APPLICATION NO.	FILING DATE	FIRST NAMED INVENTOR	ATTORNEY DOCKET NO.	CONFIRMATION NO.
10/799,534	03/12/2004	Long Sheng Yu	25658-455002	7819
7590 George H. Gerstman SEYFARTH SHAW LLP 55 East Monroe Street Chicago, IL 60603			EXAMINER ALTER, ALYSSA M	
			ART UNIT	PAPER NUMBER
			3762	
SHORTENED STATUTORY PERIOD OF RESPONSE		MAIL DATE	DELIVERY MODE	
3 MONTHS		01/29/2007	PAPER

Office Action Summary

DETAILED ACTION

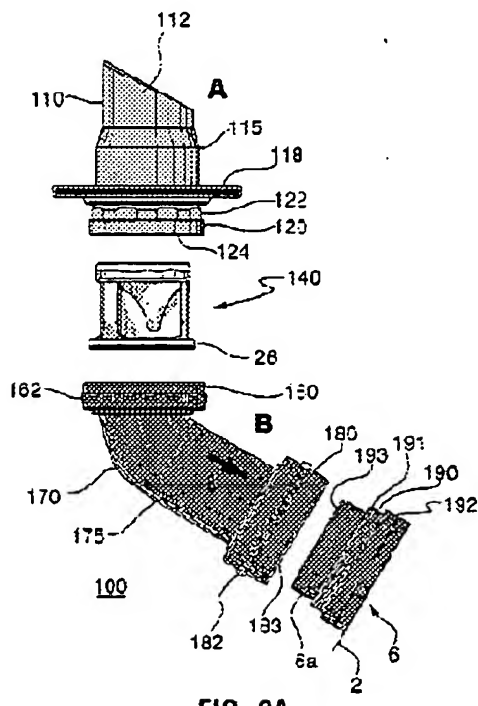
1. Claims 1-5 and 7-13 are rejected under 35 U.S.C. 102(e) as being anticipated by Mussivand et al. (US 6,290,639). Mussivand et al. discloses a conduit assembly in figure 1 and 2A. As seen in figure 1, the system includes a VAD 2 as a pump portion, an inflow tube protruding from the pump and an adapter sleeve. The inflow tube and

adapter sleeve can be seen more clearly in the replication of figure 2A below.

In figure 2A, the inflow tube is depicted as portion B and the adapter is depicted as portion A, as indicated accordingly.

As to claims 9, 11 and 13, since the inflow tube also includes the inflow port extension 6a, the examiner considers the inflow tube to be

extendable. Furthermore, this inflow port extension 6a is also an inner sleeve that extends inside the inflow tube.

As to claims 2-3 and 7, the adapter also includes a sewing ring or skirt 118 to suture to the ventricular apex. Furthermore, the examiner also considers the sewing ring or skirt 118 to be a gripping member for attaching the inflow tube to the ventricular apex.

As to claim 8, the elbow assembly 170 is the bent end of the inflow tube as seen in figure 2A.
